Church Lane Group – LETTER OF OBJECTION

Church Lane Group - 26.07.22

KEY VIEWPOINTS from ALDINGTON RIDGE

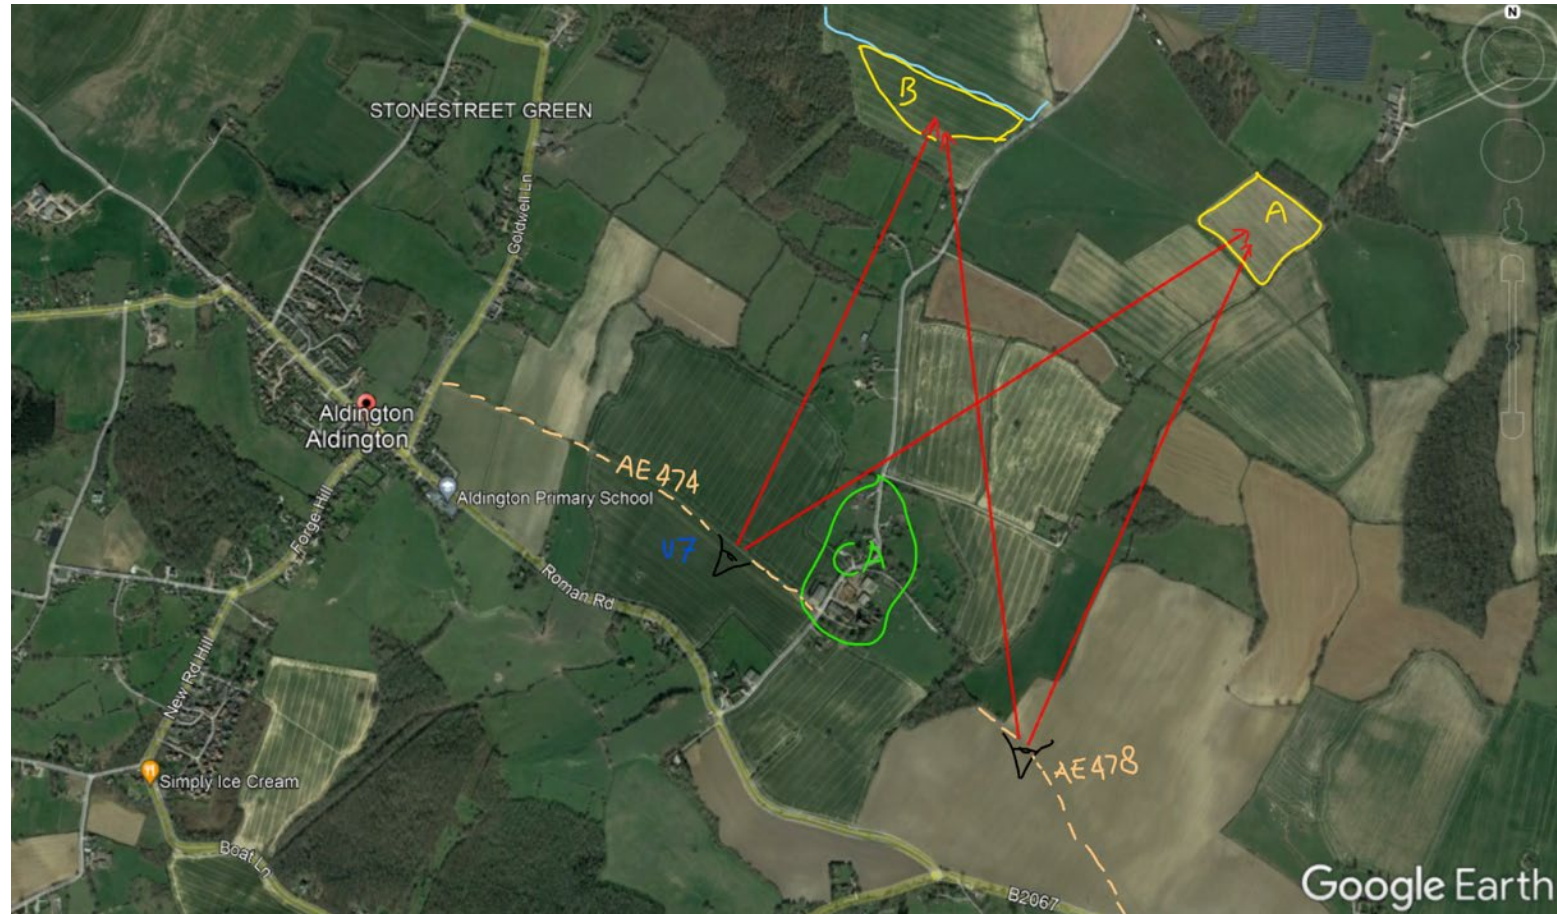
1. The slide shows on Google Earth two important viewing points on public footpaths from each of which walkers enjoy a “vista” looking across the East Stour Valley landscape to the North Downs beyond. The Conservation Area is approximately shown verged green and marked “CA”.
The inconsistency just referred to is in relation to the two areas of land marked “A” and “B”. Area A was in the original EDF plans during the consultation phase but has been subsequently removed as being too prominent in the landscape.

EDF Application Plan: Green line inserted showing panel area to be removed on south facing slope of Bested Hill

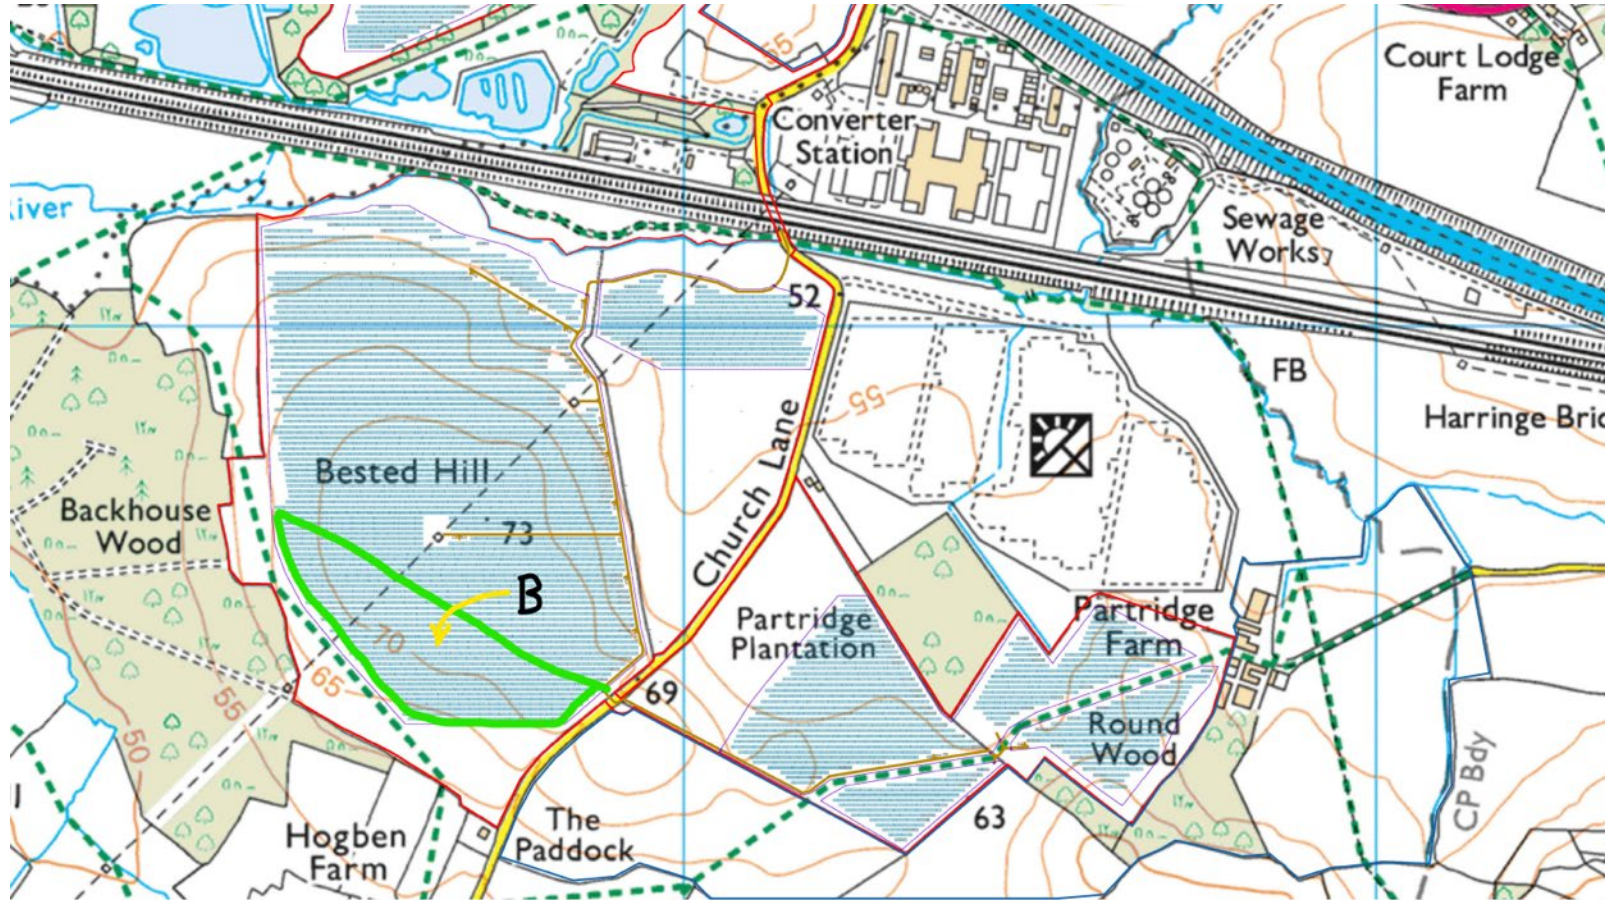
7. This slide shows the EDF planning application plan (southern element of the scheme only) on which we have superimposed vergered green the area of panel footprint that needs to be removed. Note that the new southern boundary to the panel footprint is the projection of the northern boundary of the point-to-point course on the other side of the lane.

Extent of area to be removed. Approximately 15 – 20 acres of solar panel footprint

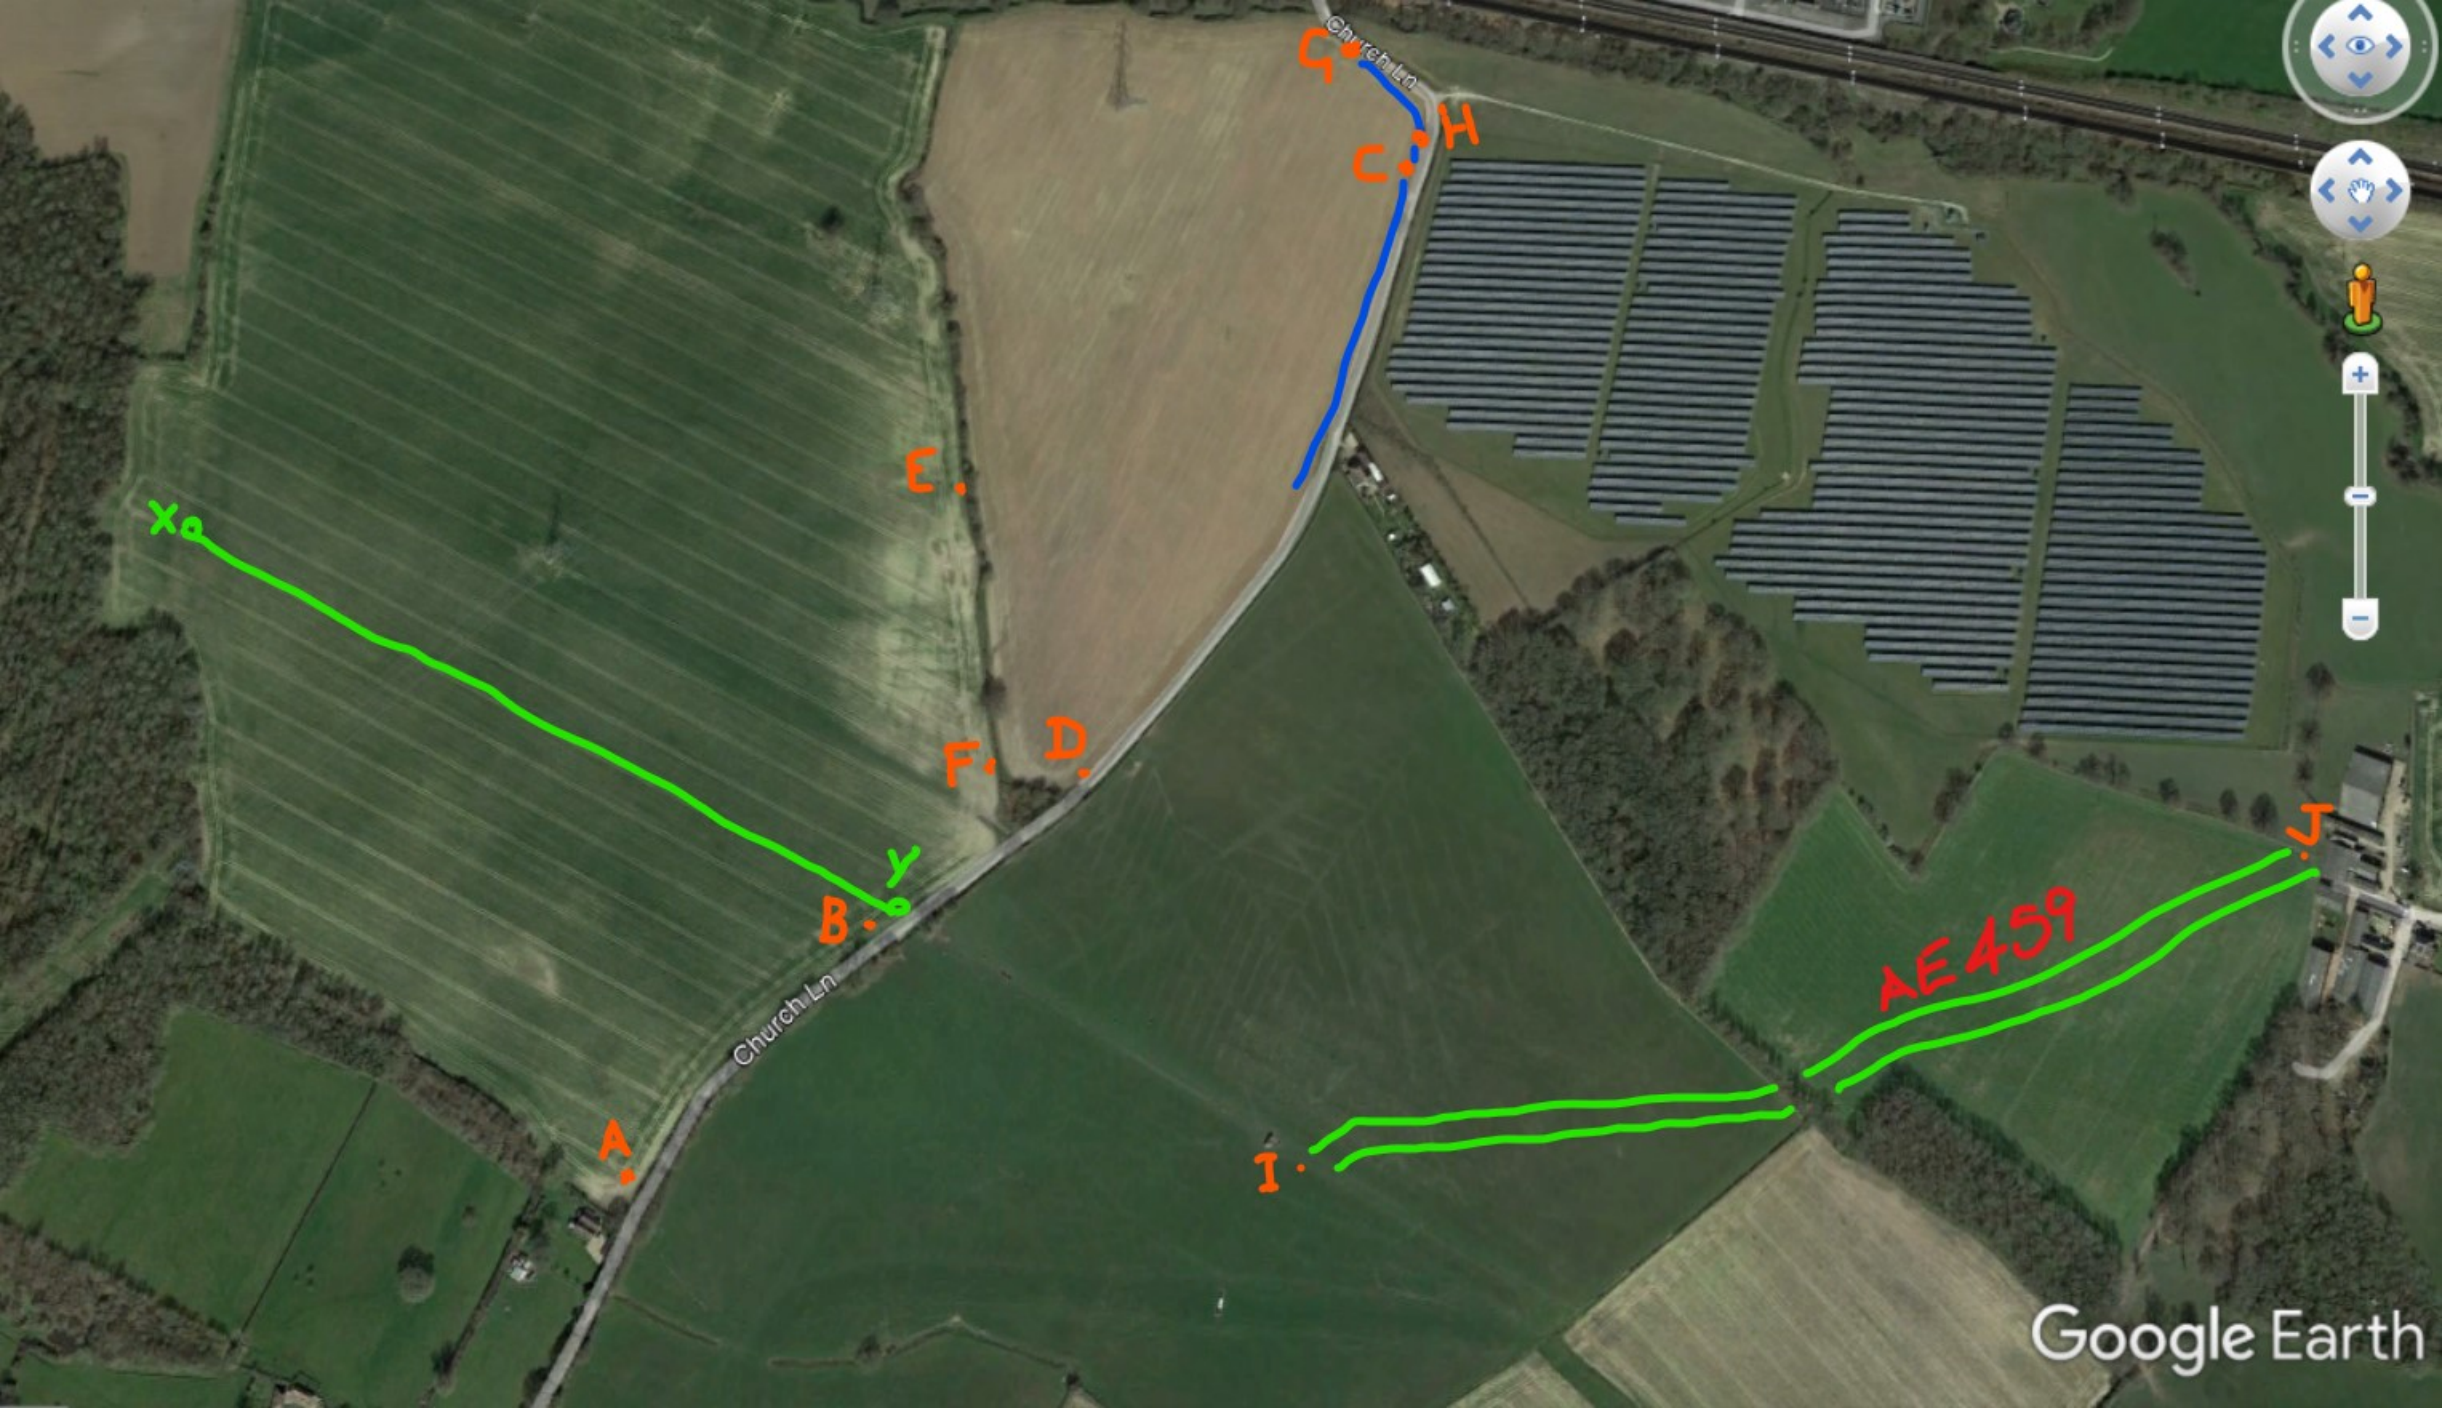
8. This slide shows an extract from Google Earth and the polygon of solar panels to be removed calculated to be between 15 and 20 acres only.
